**City of Springfield
Development and Public Works Department**

**Addendum Number 2 to the Contract Documents for the
Invitation to Bid for P21117; Main Street Pedestrian
Crossing Construction – Phase 2**

DWG: FS-07 REV: 1

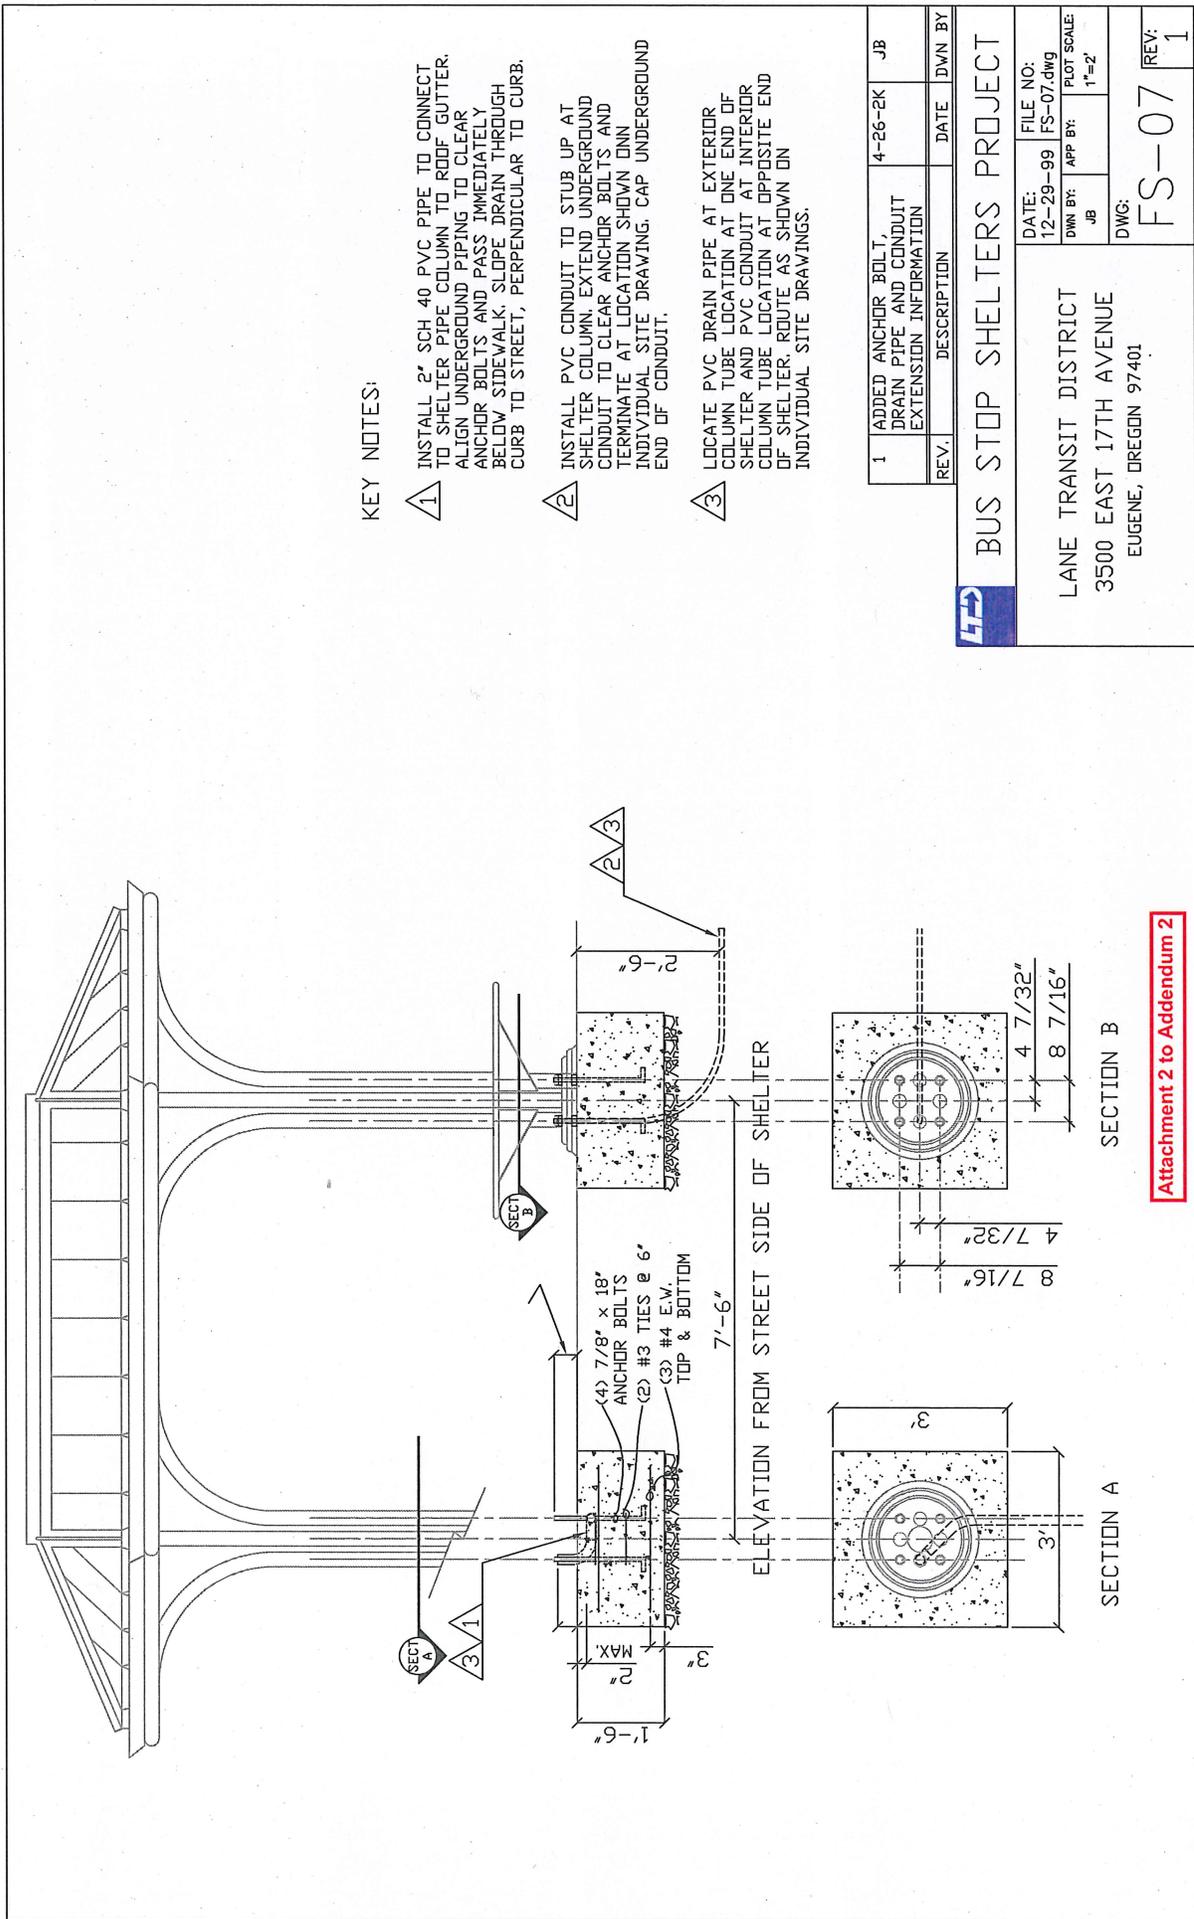
- 1.) An LTD Bus Stop Shelter located at 48th and Main St. will be removed as part of this project, including the footings and pads. Drawing number FS-07 for the LTD Bus Stop Shelter is added which shows the footings and pads to be removed. See Attachment 2 to this Addendum.
